SITE DEVELOPMENT PLAN, AMENDMENT NO. 1 THE BRINKERHOFF & BAR HUMMINGBIRD

LOT 1A-3A, BLOCK 2, PROMENADE AT CASTLE ROCK FILING NO. 1, AMENDMENT NO. 13
LOCATED IN THE SW QUARTER OF SECTION 22, TOWNSHIP 7 SOUTH, RANGE 67 WEST,
OF THE 6TH PRINCIPAL MERIDIAN, TOWN OF CASTLE ROCK, COUNTY OF DOUGLAS, STATE OF COLORADO

CHANGES FROM APPROVED SDP AMENDMENT #1

REVISION SDP AMENDMENT

SITE PLAN
NO. 3 OF 19

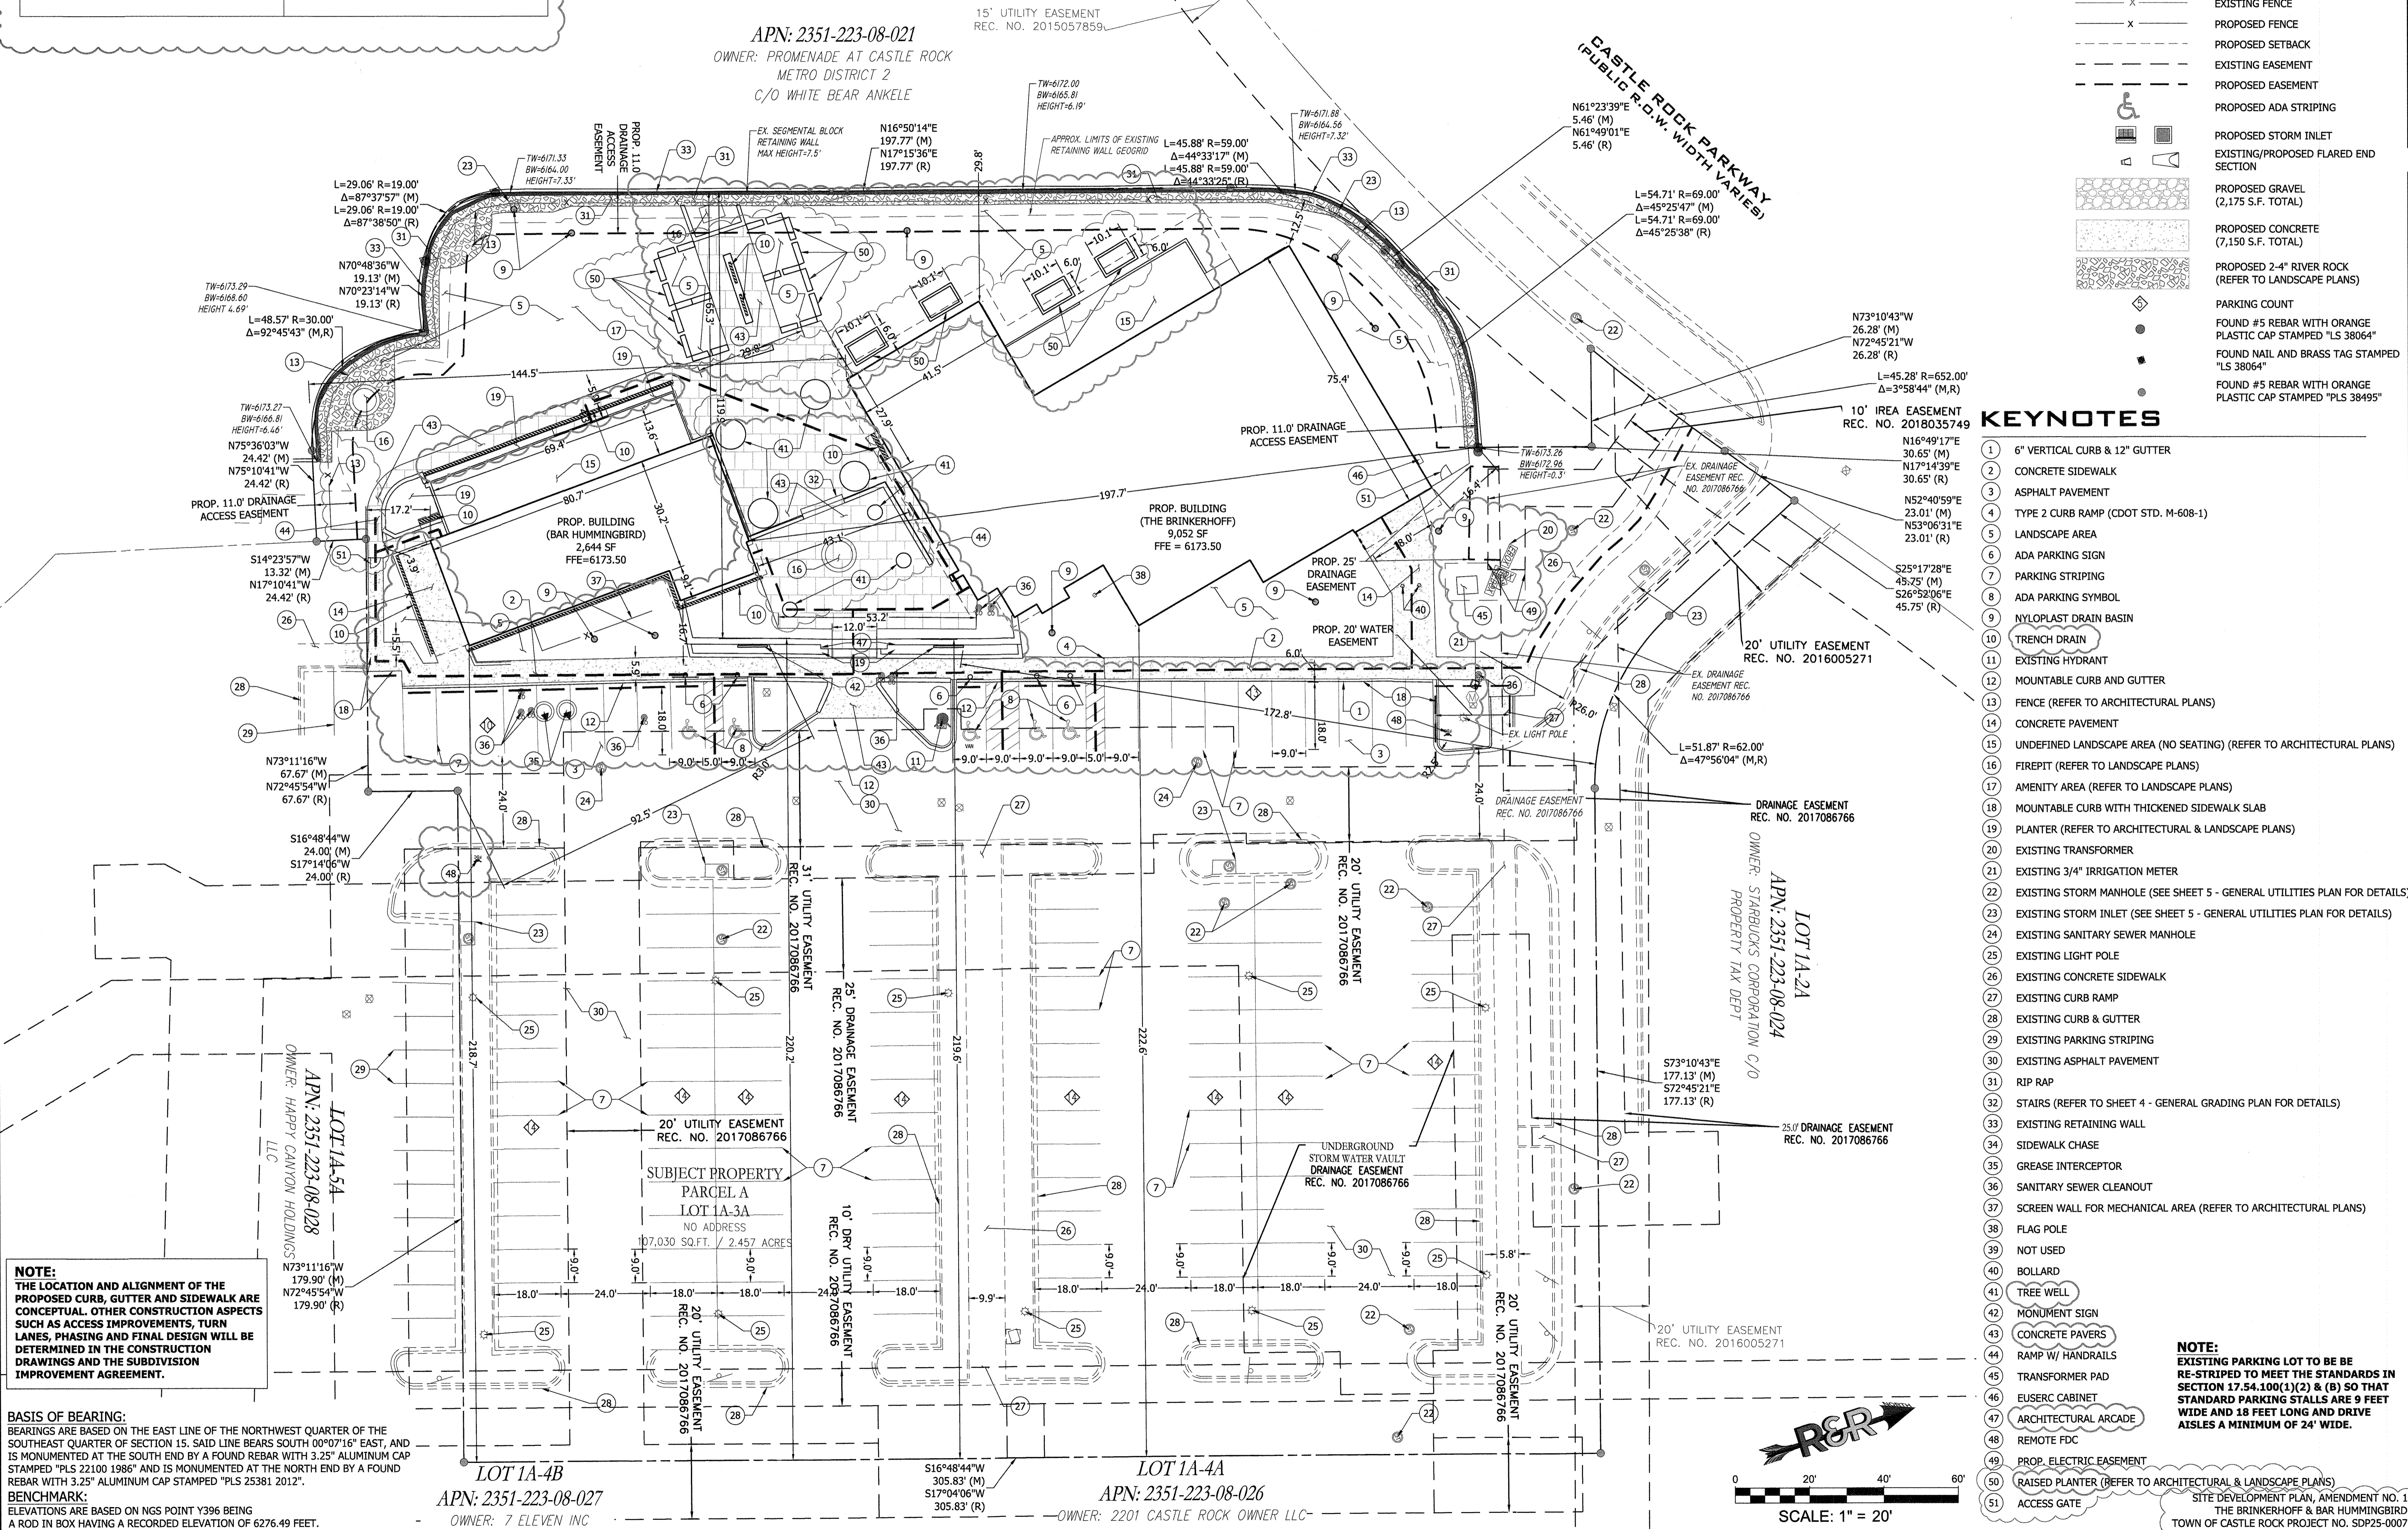
CHANGES FROM APPROVED SDP AMENDMENT #1

DESCRIPTION	REASONING
CALL OUTS ADDED TO PLANS WHERE REQUESTED	RAISED PLANTER CALLOUTS MISSING FROM SITE PLAN, DETAILS FOR RAISED PLANTERS TO BE PROVIDED BY LANDSCAPING & ARCHITECTURE
ACCESS GATE AND ASSOCIATED CALL OUT ADDED TO PLANS	GATE PROVIDE TO ALLOW ACCESS TO EUSERC CABINET

THE BRINKERHOFF & BAR HUMMINGBIRD
 CASTLE ROCK PROMENADE, BLOCK 2
 CASTLE ROCK, COLORADO 80108
LANDSCAPE ENLARGEMENT PLAN

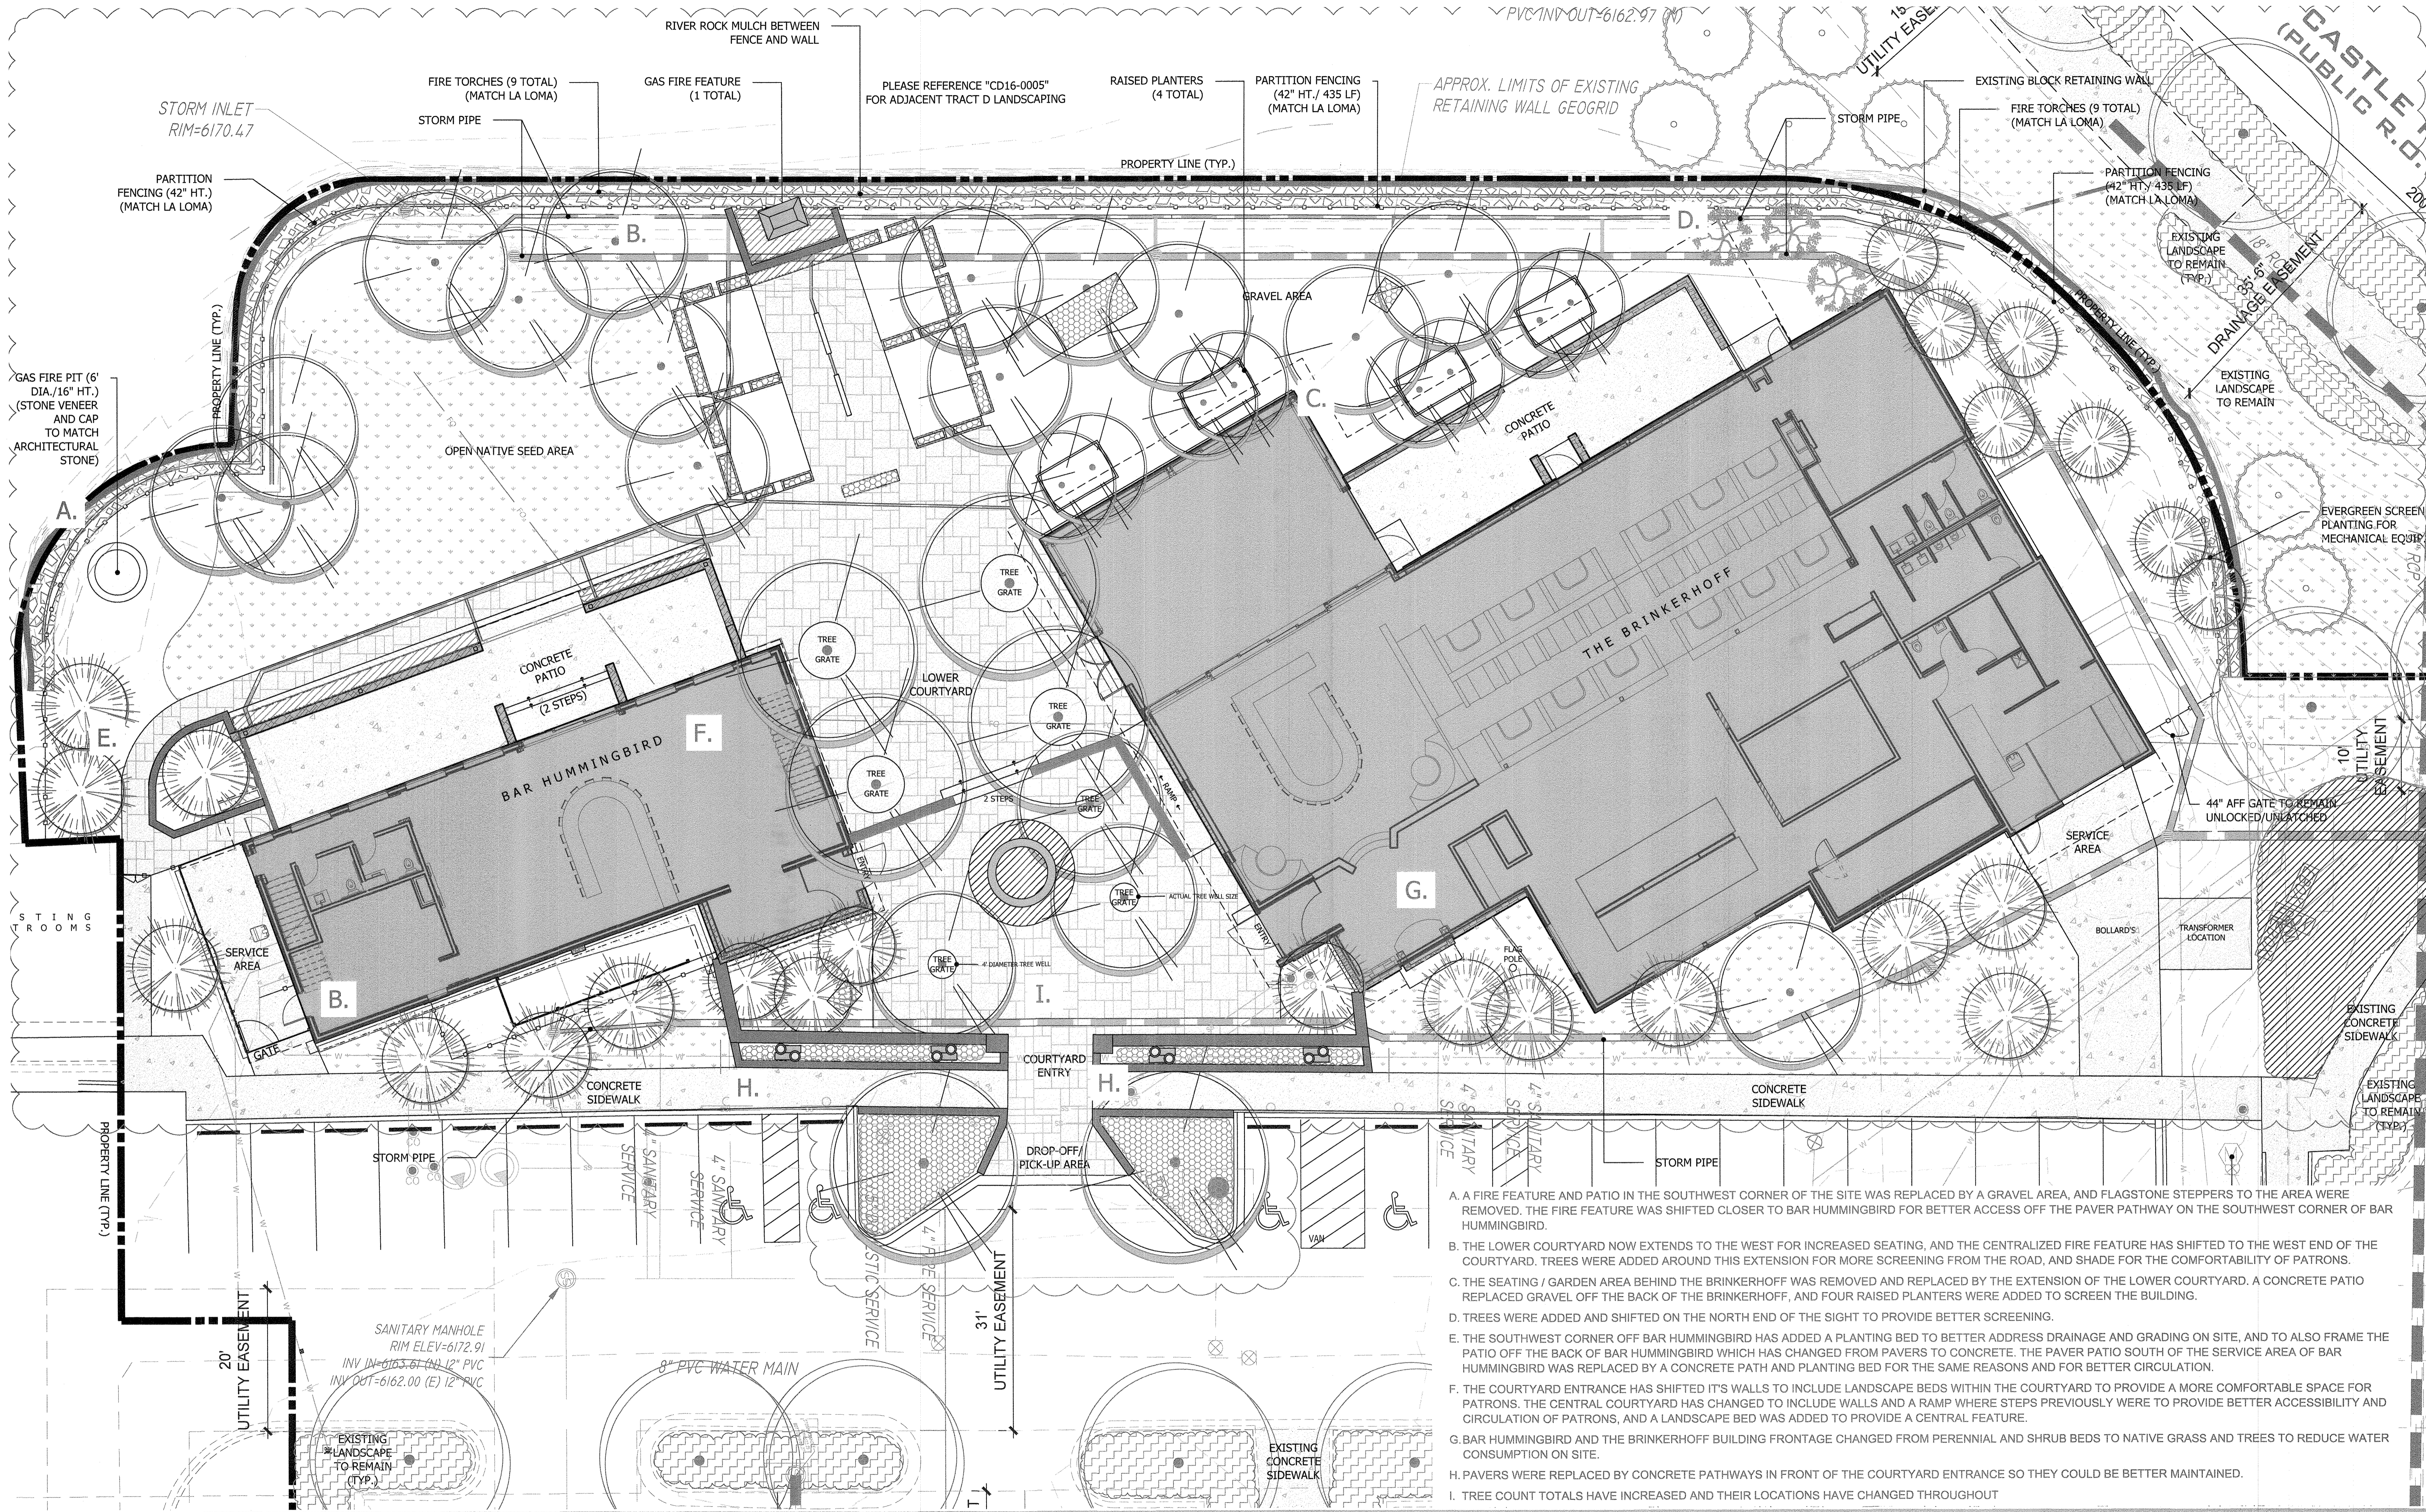
- A. A FIRE FEATURE AND PATIO IN THE SOUTHWEST CORNER OF THE SITE WAS REPLACED BY A GRAVEL AREA, AND FLAGSTONE STEPPERS TO THE AREA WERE REMOVED. THE FIRE FEATURE WAS SHIFTED CLOSER TO BAR HUMMINGBIRD FOR BETTER ACCESS OFF THE PAVER PATHWAY ON THE SOUTHWEST CORNER OF BAR HUMMINGBIRD.

- B. THE LOWER COURTYARD NOW EXTENDS TO THE WEST FOR INCREASED SEATING, AND THE CENTRALIZED FIRE FEATURE HAS SHIFTED TO THE WEST END OF THE COURTYARD. TREES WERE ADDED AROUND THIS EXTENSION FOR MORE SCREENING FROM THE ROAD, AND SHADE FOR THE COMFORTABILITY OF PATRONS.

- C. THE SEATING / GARDEN AREA BEHIND THE BRINKERHOFF WAS REMOVED AND REPLACED BY THE EXTENSION OF THE LOWER COURTYARD. A CONCRETE PATIO REPLACED GRAVEL OFF THE BACK OF THE BRINKERHOFF, AND FOUR RAISED PLANTERS WERE ADDED TO SCREEN THE BUILDING.

- D. TREES WERE ADDED AND SHIFTED ON THE NORTH END OF THE SIGHT TO PROVIDE BETTER SCREENING.
- E. THE SOUTHWEST CORNER OFF BAR HUMMINGBIRD HAS ADDED A PLANTING BED TO BETTER ADDRESS DRAINAGE AND GRADING ON SITE, AND TO ALSO FRAME THE PATIO OFF THE BACK OF BAR HUMMINGBIRD WHICH HAS CHANGED FROM PAVERS TO CONCRETE. THE PAVER PATIO SOUTH OF THE SERVICE AREA OF BAR HUMMINGBIRD WAS REPLACED BY A CONCRETE PATH AND PLANTING BED FOR THE SAME REASONS AND FOR BETTER CIRCULATION.

- F. THE COURTYARD ENTRANCE HAS SHIFTED IT'S WALLS TO INCLUDE LANDSCAPE BEDS WITHIN THE COURTYARD TO PROVIDE A MORE COMFORTABLE SPACE FOR PATRONS. THE CENTRAL COURTYARD HAS CHANGED TO INCLUDE WALLS AND A RAMP WHERE STEPS PREVIOUSLY WERE TO PROVIDE BETTER ACCESSIBILITY AND CIRCULATION OF PATRONS, AND A LANDSCAPE BED WAS ADDED TO PROVIDE A CENTRAL FEATURE.
